Access Compliance Report

Public Rights-of-Way

Intersection ID: 10019902	Main Street: ARCO_CORPORATE_DR	Cross Street: N/A	Location: SE
ADA ID: F164AE434FDD	Ramp Type: PerpDiag	Initial Pass/Fail: Fail	Overall Compliance: No
		Severity Score: 12.5	
Codes/Mitigation Info/Possible Solution		Field Measurements/Component Compliance

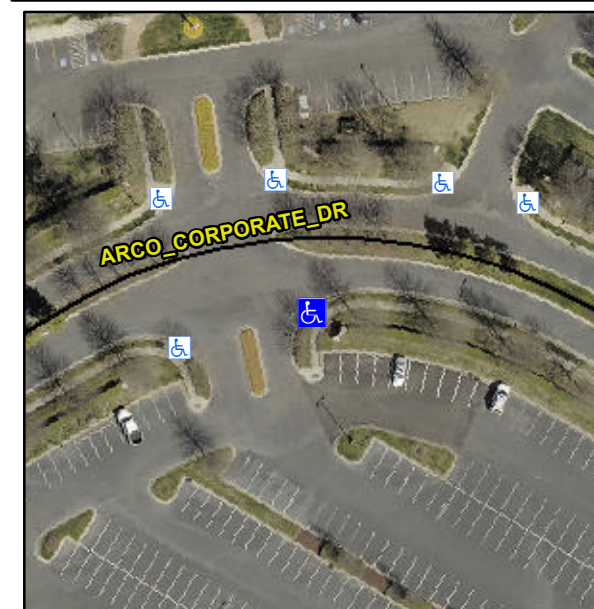
Not Found, R304.2.2

Compliance	Description	Data	Compliance	Description	Data
N/A	Ramp Length (in)	58.0	No	Ramp Slope (%)	8.7
Yes	Ramp Width (in)	48.0	Yes	Ramp XSlope (%)	2.0
N/A	Flare Type LT	N/A	N/A	Flare Type RT	N/A
N/A	Flare Slope LT (%)	N/A	N/A	Flare Slope RT (%)	N/A
N/A	Flare Traversable LT?	N/A	N/A	Flare Traversable RT?	N/A
N/A	Landing Length (in)	N/A	N/A	DWS Provided?	N/A
N/A	Landing Width (in)	N/A	N/A	DWS Contrast?	N/A
N/A	Landing Slope (%)	N/A	N/A	DWS Length (in)	N/A
N/A	Landing X Slope (%)	N/A	N/A	DWS Full Width?	N/A
N/A	Landing Curb? (Y/N)	N/A	N/A	DWS Offset (in)	N/A
N/A	Shared Landing?	N/A			
N/A	Gutter Ponding?	N/A	N/A	Gutter Slope (%)	N/A
N/A	Gutter Lip Ht (in)	N/A	N/A	Gutter X Slope (%)	N/A
N/A	Painted X Walk1?	No	N/A	Painted X Walk2?	No
	X Walk 1 Direction	To N		X Walk 2 Direction	To W
N/A	X Walk 1 Width (in)	N/A	N/A	X Walk 2 Width (in)	N/A
	X Walk 1 Slope (%)	1.1		X Walk 2 Slope (%)	4.0
	X Walk 1 X Slope (%)	3.7		X Walk 2 X Slope (%)	0.6

Remove & Replace Curb Ramp With Two New Directional Ramps or Equivalent.
